*Re: Application of Dino and Michelle DeLaurentiis for Site Plan Approval for the
Construction of a Single-Family Residence and a Tree Removal Permit
To Permit Tree Removal in Connection with the Development of the Residence
Property: 21 Nethermont Ave. North Castle Tax Map Section 122.16, Block 4, Lot 41*

MEMORANDUM

SUBJECT: 21 Nethermont Ave

DATE: June 21, 2022

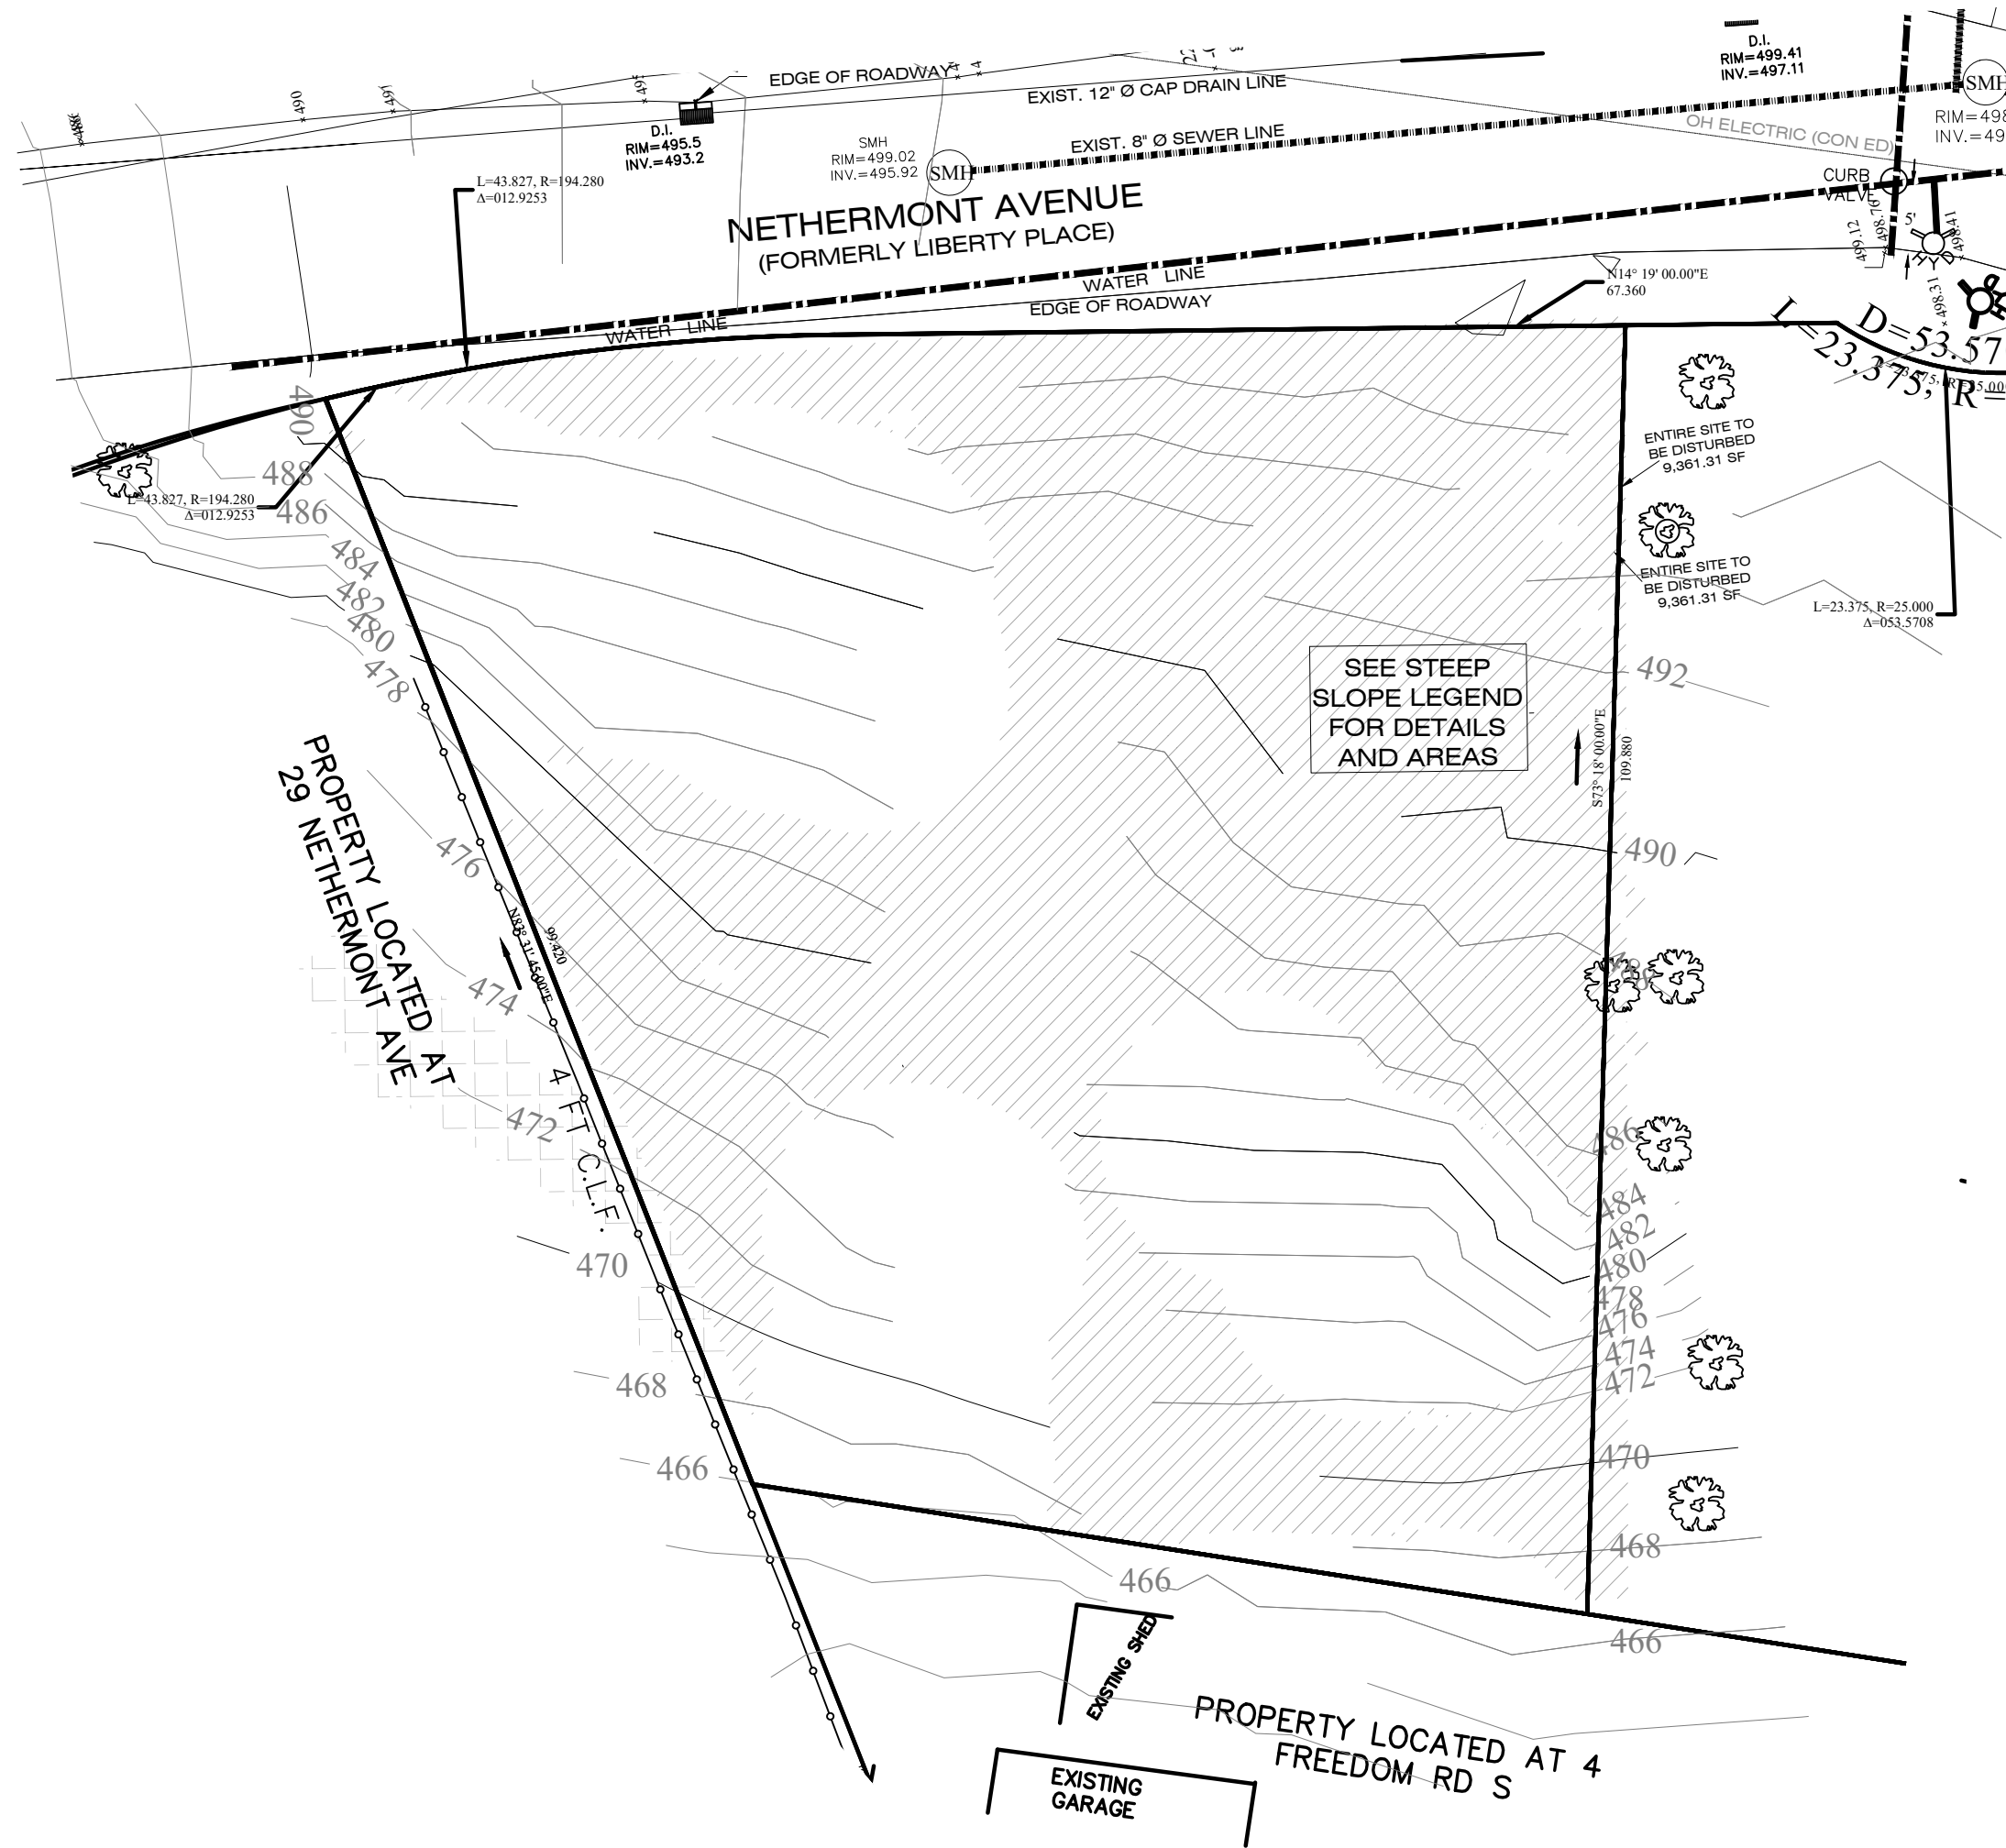
5. As previously requested, the net lot area calculations shall be removed from Sheet TS-1 "Existing Conditions, Topographic Survey & Steep Slope Analysis", since that is only applicable to subdivisions.

The above requested revision has not been addressed.

Net lot area calculations have been removed from this plan. (Sheet TS-1)

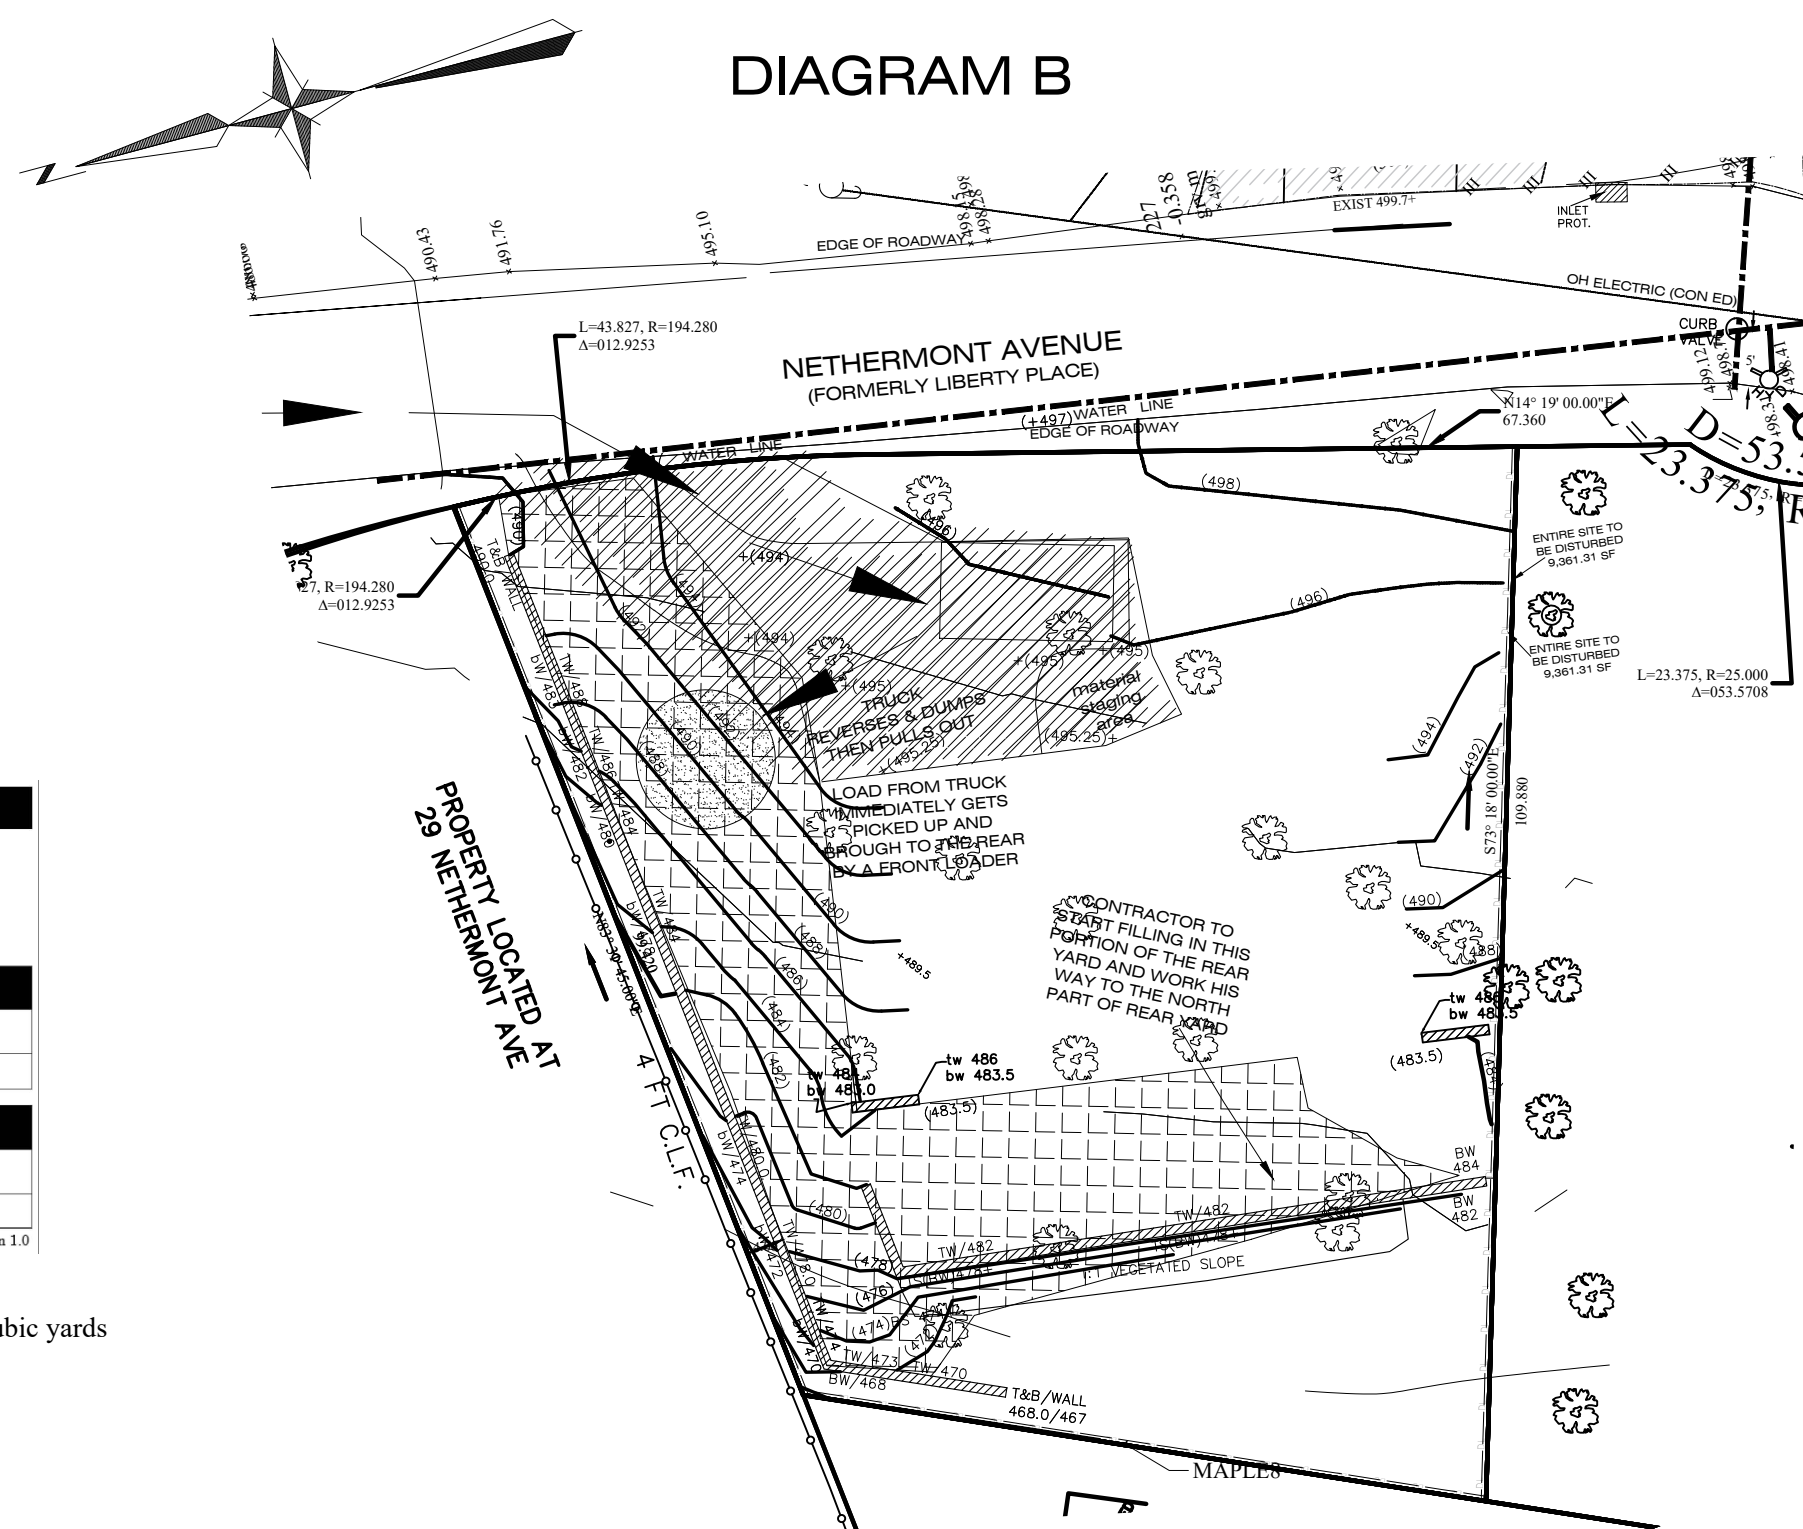
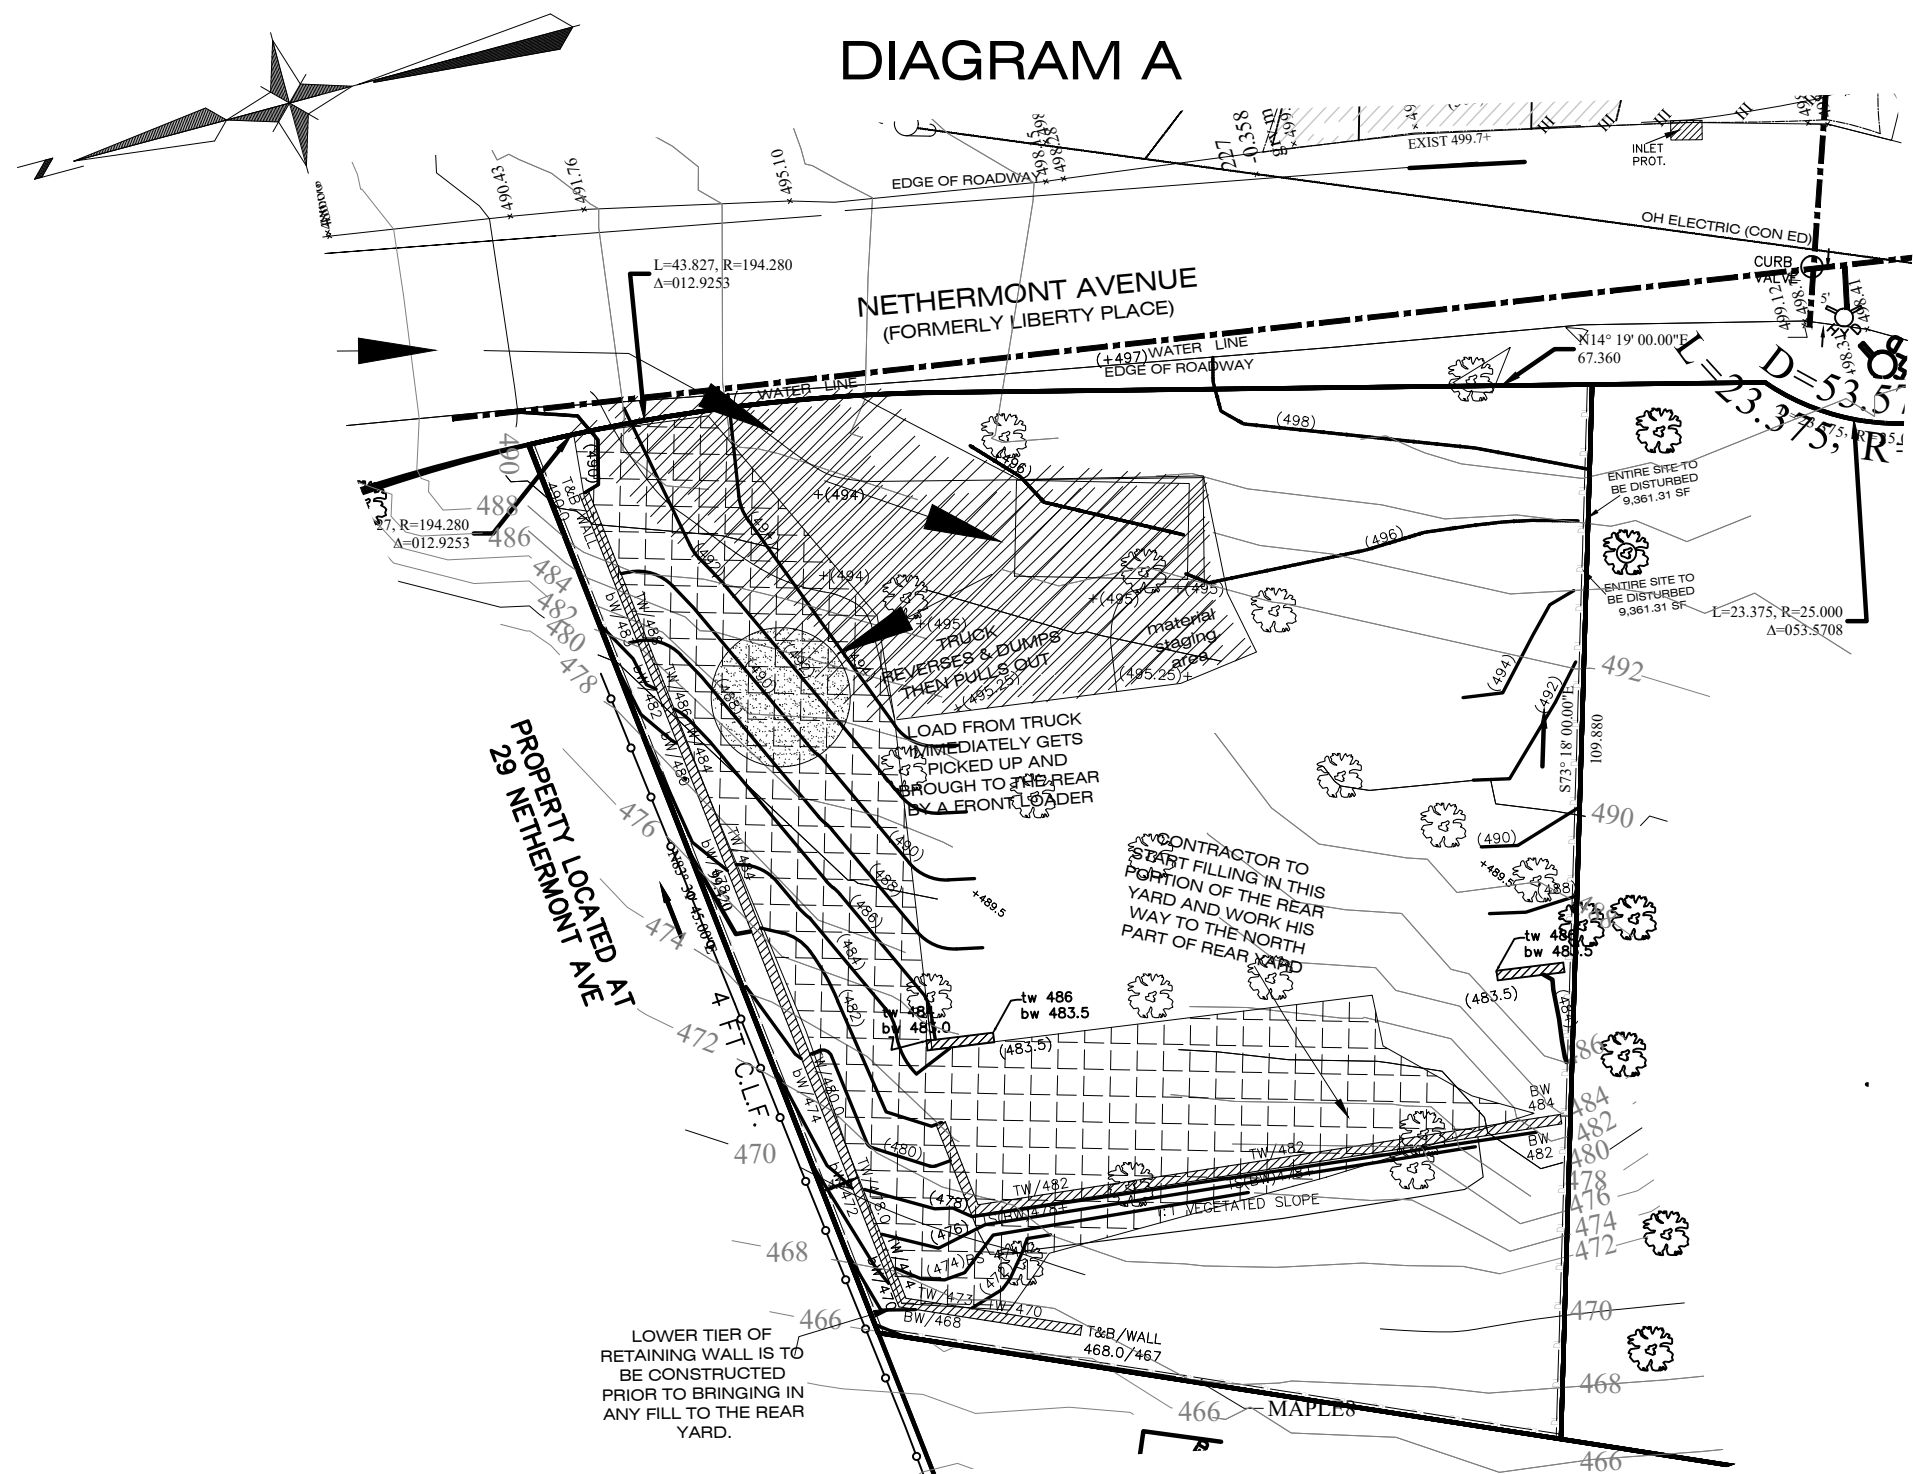
- 1 As previously noted, the applicant has provided cut and fill volume estimates for the development indicating that the proposed plan requires the import of approximately 900 cubic yards of fill. Given the condition of the existing roadways in the neighborhood (narrow, winding, steep), this office is concerned with the amount of truck traffic required for delivery and potential damage to existing roads. We recommend that the application is referred to the Highway Department for review and comment.

The Fill Delivery and Material Staging Plan has been revised to indicate that 275 cubic yards of fill is now required. It is not clear how the reduction is realized given that there is no significant change to the plan. It is also not clear whether this calculation includes the excavation and fill required for the building foundation. The applicant should provide a cut/fill map for review and clarification and continue to seek comment from the Highway Department.

2. As previously requested, notes shall be added to the "Fill Delivery and Material Staging Plan" specifying compaction requirements and the fill material specifications.

Compaction requirements have been added as requested. However, the plan shall be revised to include the requested fill material specifications and requirements in accordance with Chapter 161: Filling and Grading related to fill delivery manifests and certification that the material complies with 6 NYCRR, Part 360.

Fill delivery and Material Staging plan has been updated with a calculation study of cut and fill. The net fill will be approximately 580 cubic yards. It is anticipated that it will take approximately 4 days for the delivery of such fill. It will be restricted to delivery after 9 am and to approximately 8 truckloads a day. Approximately 10 cubic yards will be removed for the foundation excavation. Bear in mind a house of this size on a level lot would produce approximately 380 cubic yards of fill to be removed. Thus, the generated transportation of fill has not been significantly increased (approximately 8 extra truckloads in comparison) from normal construction procedures.

Fill delivery and Material Staging plan has been revised with above notation.
